**ADDENDUMNO. 1
RFTWORK ASSIGNMENT NO. CREM-PMO-24-017
IN ACCORDANCE WITH
REQUEST FOR SUPPLIER QUALIFICATION (RFSQ) NO. Doc 3512316731
Revised Closing September 27, 2024**

HVAC System Modifications & Upgrades for Building A involving all Floors at 150 Disco RD (Disco Yard).

Drawing Detail Reference:

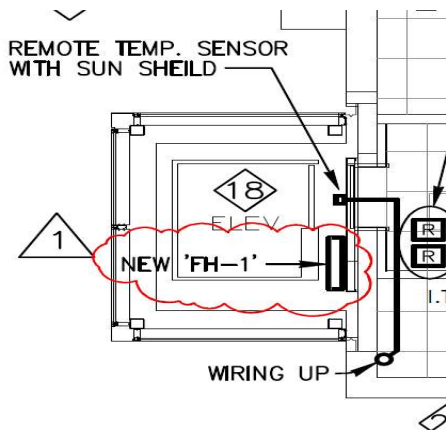
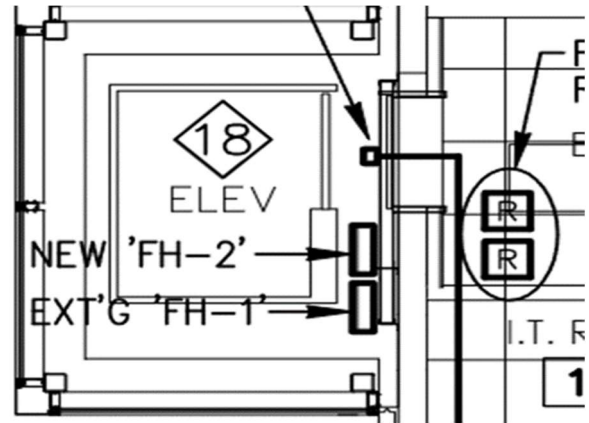
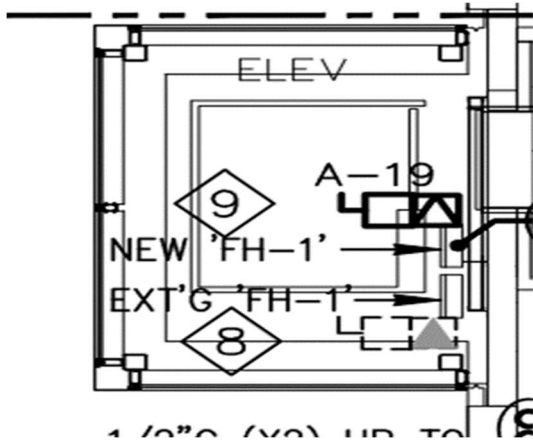
- 3- I found something contradictory between mechanical drawing and electrical drawing:
 In electrical drawing, we need to replace the existing FH-1 with a new one. There is no FH-2 on electrical drawings. However, on mechanical drawings it is different, there is a new "FH-2" here. Please advise which one is correct.

Answer: It is a typo error on the floor plan. There is only one new 347V 8kW fan heater 'FH-1' as shown on sketch below. Its specification is in the "Fan Heater Schedule" on drawing M-2. This fan heater is to replace the existing 208V 4kW fan heater.
